## **Hammond & Champness Single Speed SAPB Controllers**

**SUBJECT : H + C Single Speed , S.A.P.B Controllers.**

A potential safety problem has been recognised on our single speed, S.A.P.B. controllers manufactured between 1976 and 1988 to wiring diagram nos. W1001, W1002, W1005, W1009, W1010 .

# EXTRACT FROM DIAGRAM W1002/D/1 Sheet 1 of 2.

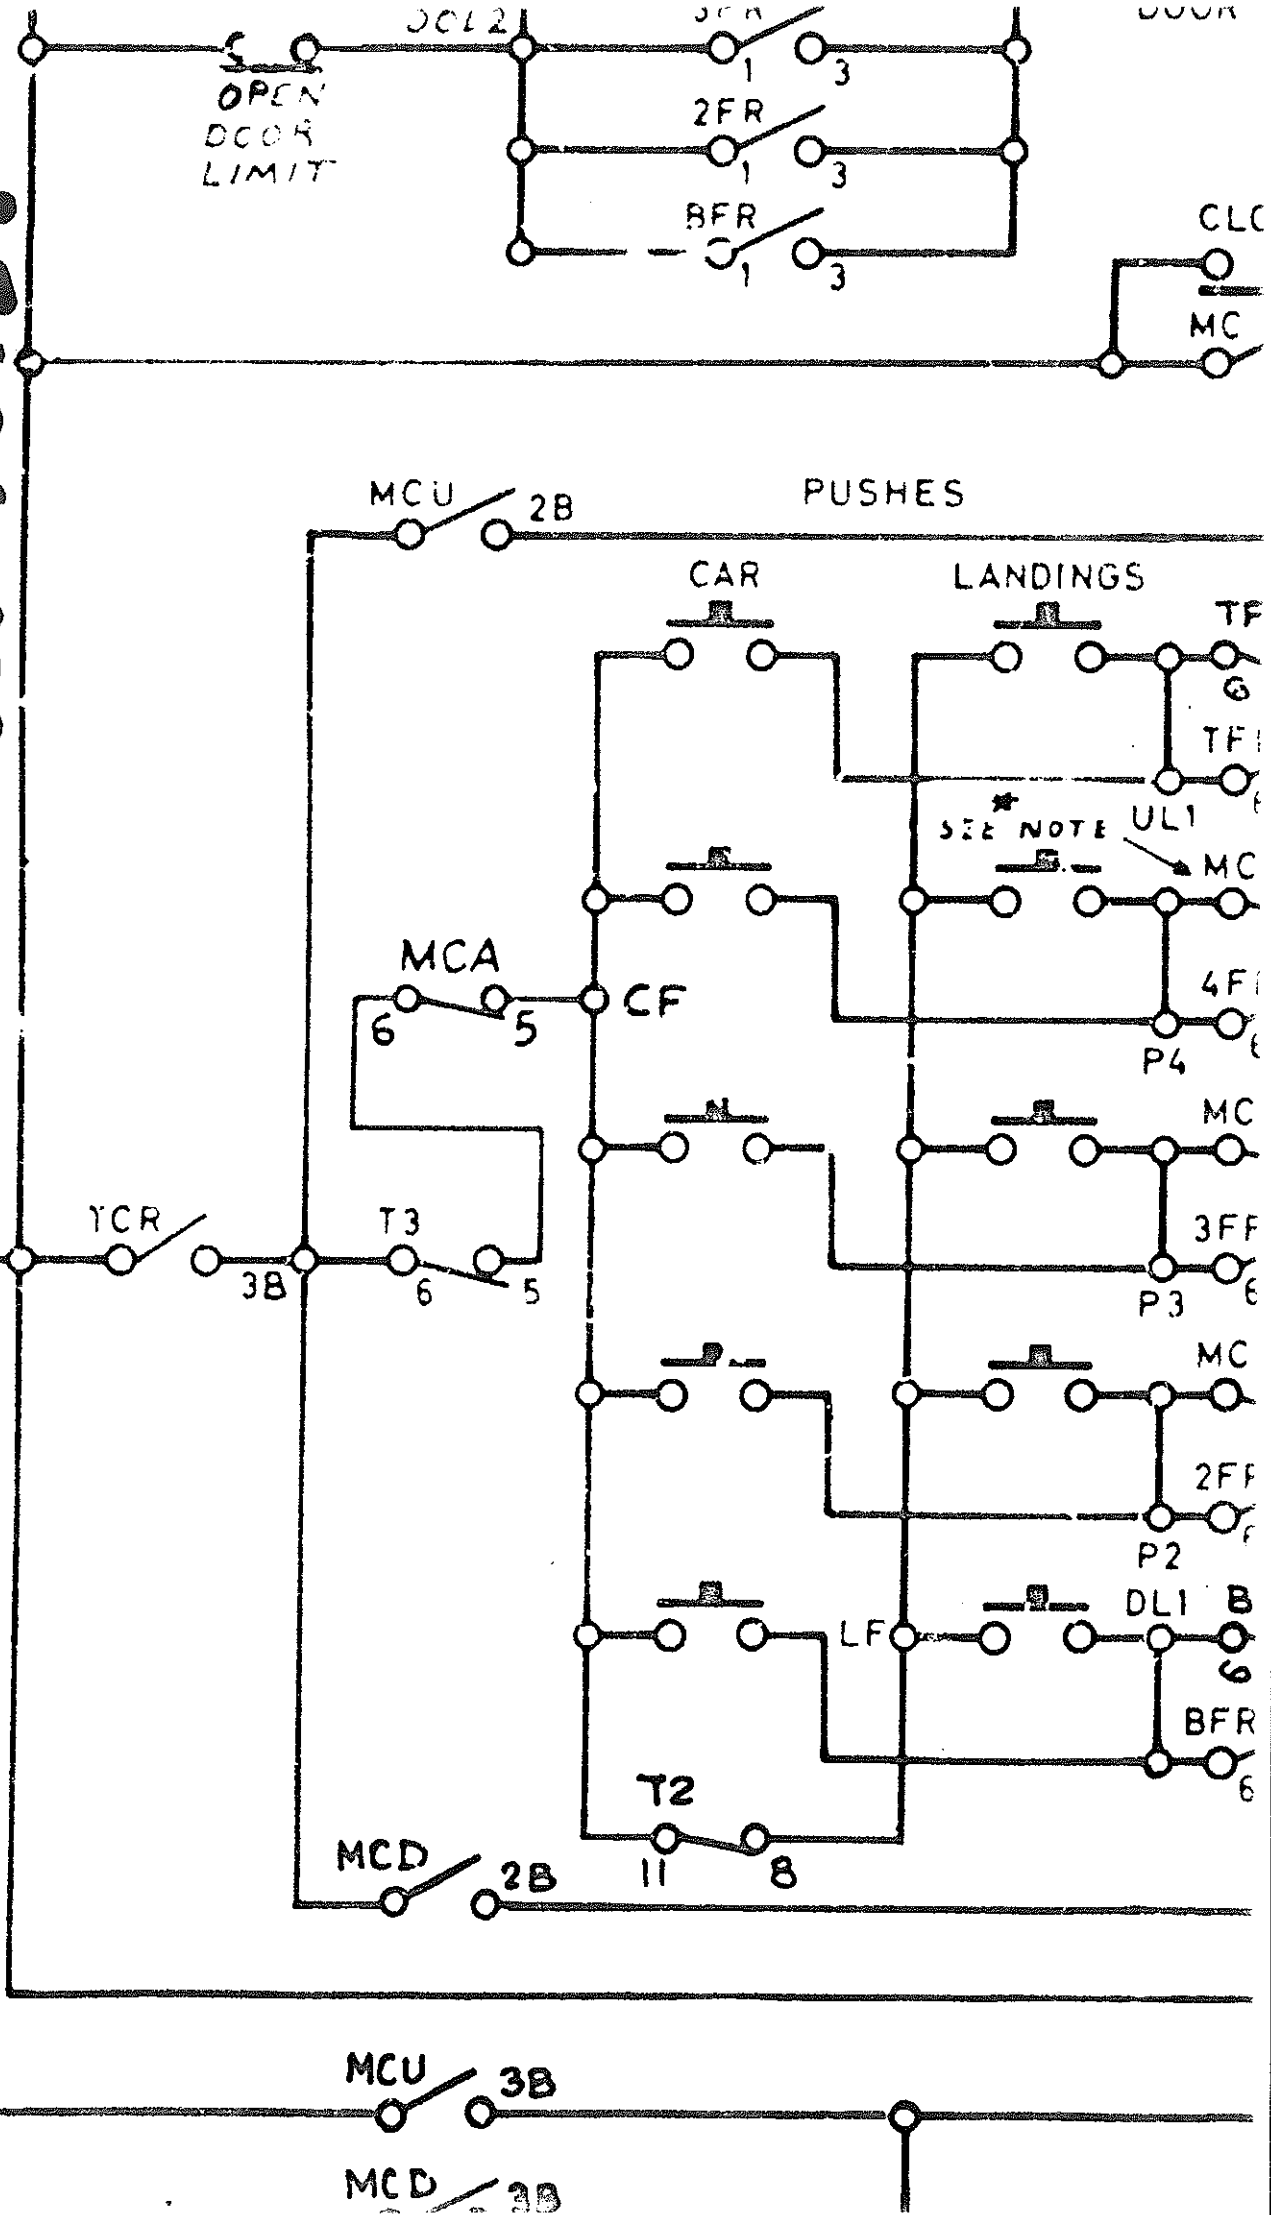
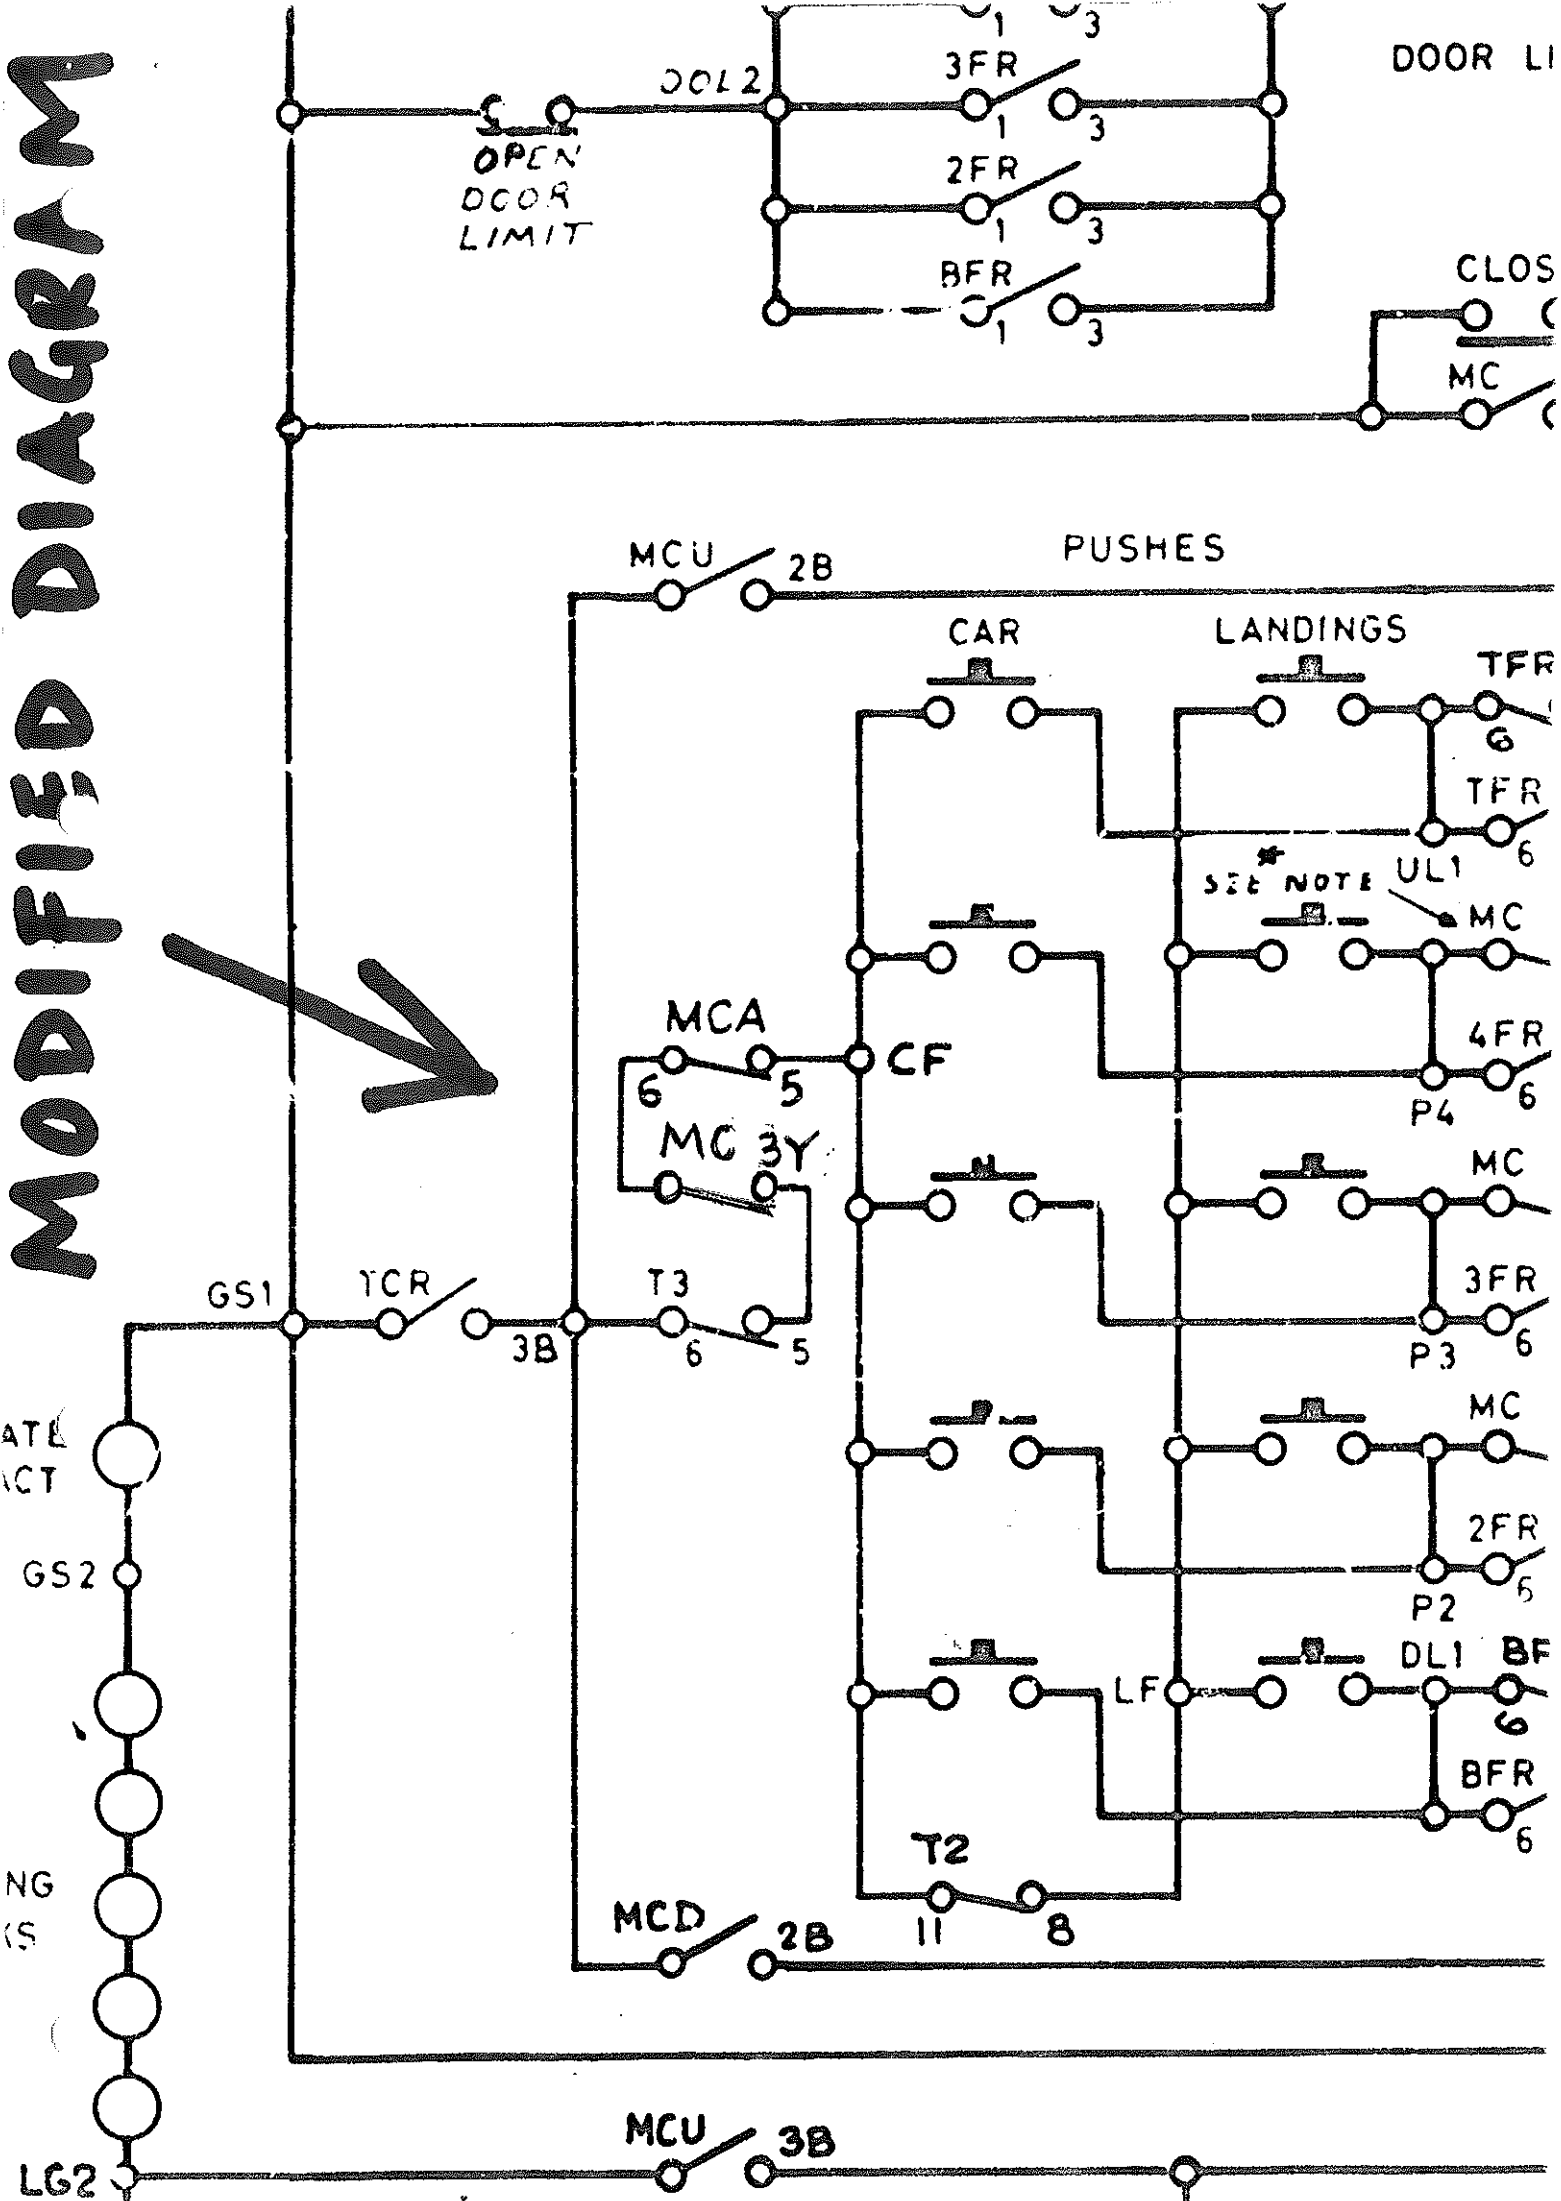
The problem could occur in the unlikely event that the Main Contactor partially jams and timer T3 times out allowing the lift to respond to calls whether the doors closed or open.

To correct the situation the circuit can be readily modified by inserting a MC/3Y contact between T3/5 and MCA/6. This will ensure that if the contactor jams, as described, no calls will be allowed to register. An extract of the original wiring diagram and the corresponding part of the diagram with the modifications added is enclosed..
